**SURRY POWER STATION**

**PROPOSED TECHNICAL SPECIFICATION CHANGES**

**DISCUSSION OF CHANGES AND  
SIGNIFICANT HAZARDS CONSIDERATION**

**SURRY POWER STATION  
SURRY CORE UPRATE LICENSING REPORT**

TS FIGURE 2.1-1  
REACTOR CORE THERMAL AND  
HYDRAULIC SAFETY LIMITS  
THREE LOOP OPERATION, 100% FLOW

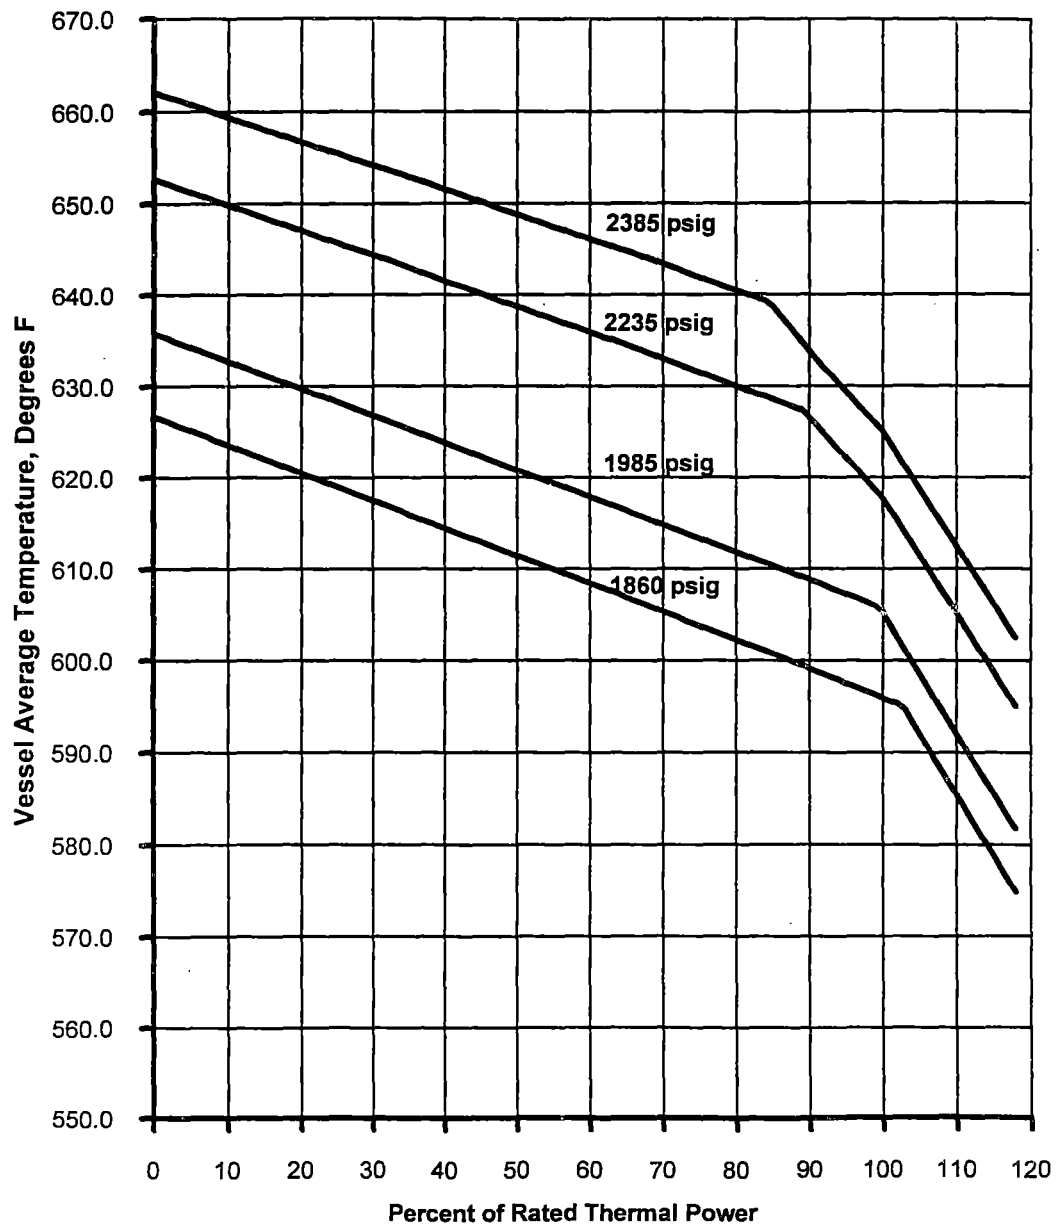
The curves of TS Figure 2.1-1 which show the allowable power level decreasing with increasing temperature at selected pressures for constant flow (three loop operation) represent limits equal to, or more conservative than, the loci of points of thermal power, coolant system average temperature, and coolant system pressure for which the calculated DNBR is not less than the design DNBR limit or the average enthalpy at the exit of the vessel is equal to the saturation value. The area where clad integrity is assured is below these lines. The temperature limits are considerably more conservative than would be required if they were based upon the design DNBR limit alone but are such that the plant conditions required to violate the limits are precluded by the self-actuated safety valves on the steam generators. The effects of rod bowing are also considered in the DNBR analyses.

TS Figure 2.1-1 is based on a 1.55 cosine axial flux shape and a statistical treatment of key DNBR analysis parameter uncertainties including an enthalpy rise hot channel factor which follows the following functional form:  $F\Delta H(N) = 1.56 [1 + 0.3(1-P)]$  where P is the fraction of RATED POWER. The limits include margin to accommodate rod bowing.<sup>(1)</sup> TS Figures 2.1-2 and 2.1-3 are based on an  $F\Delta H(N)$  of 1.55, a deterministic treatment of key DNB analysis parameter uncertainties, and include a 0.2 rather than 0.3 part power multiplier for the enthalpy rise hot channel factor. The  $F\Delta H(N)$  limit presented in the unit- and reload-specific CORE OPERATING LIMITS REPORT is confirmed for each reload to be accommodated by the Reactor Core Safety Limits.

# TS FIGURE 3.8-1

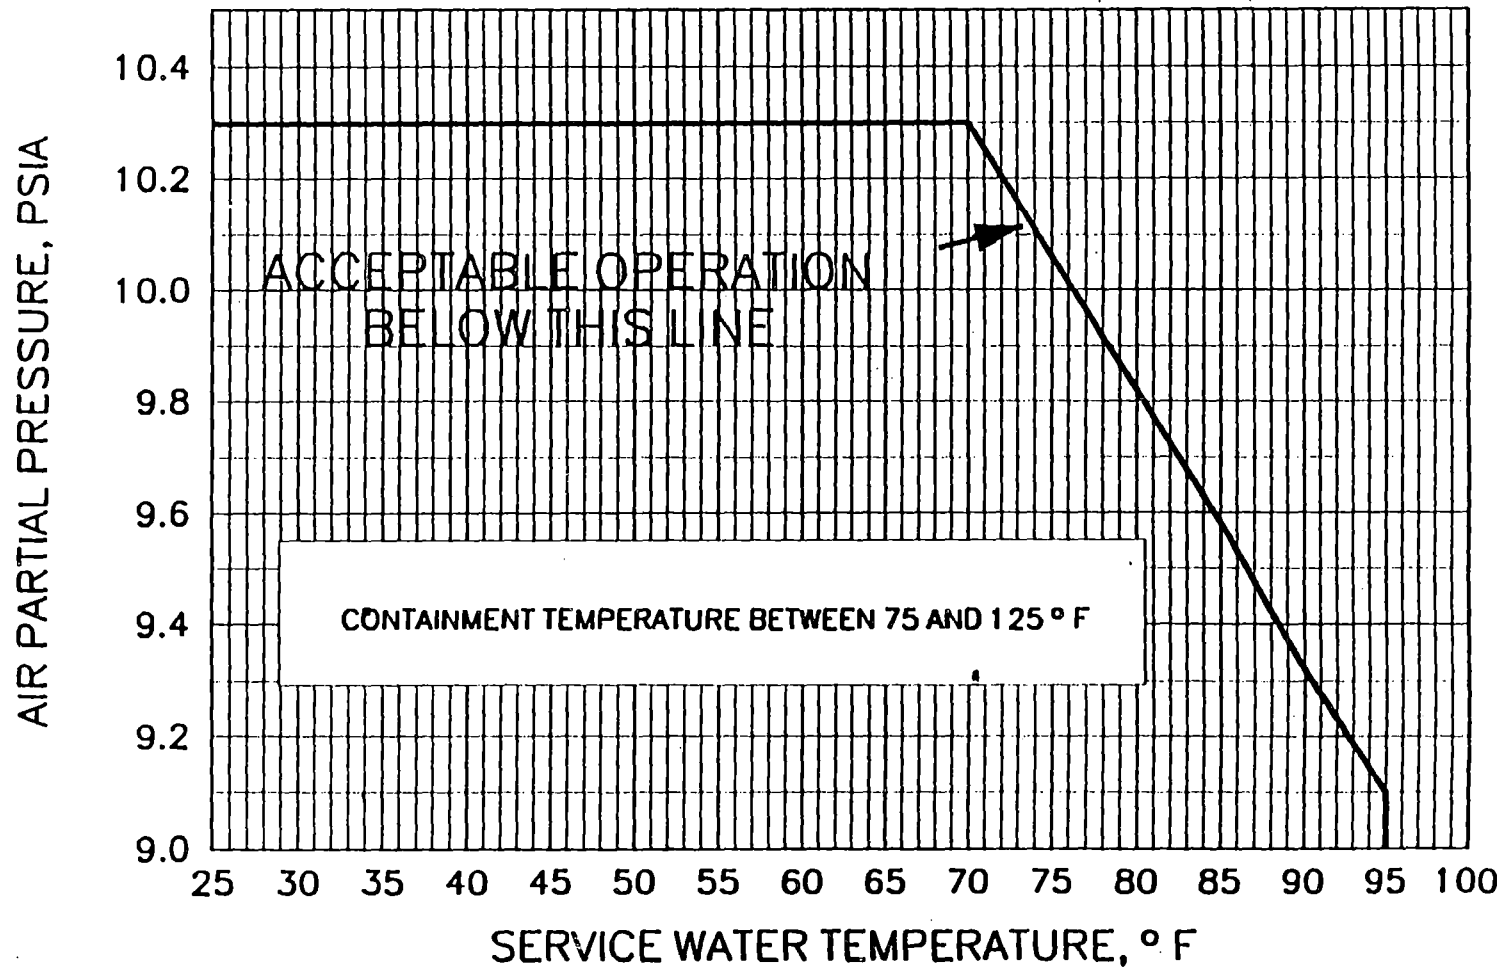
The allowable value for the containment air partial pressure is presented in TS Figure 3.8-1 for service water temperatures from 25 to 95°F. The RWST water shall have a maximum temperature of 45°F.

The horizontal limit line in TS Figure 3.8-1 is based on LOCA peak calculated pressure criteria, and the sloped line is based on LOCA subatmospheric peak pressure criteria.
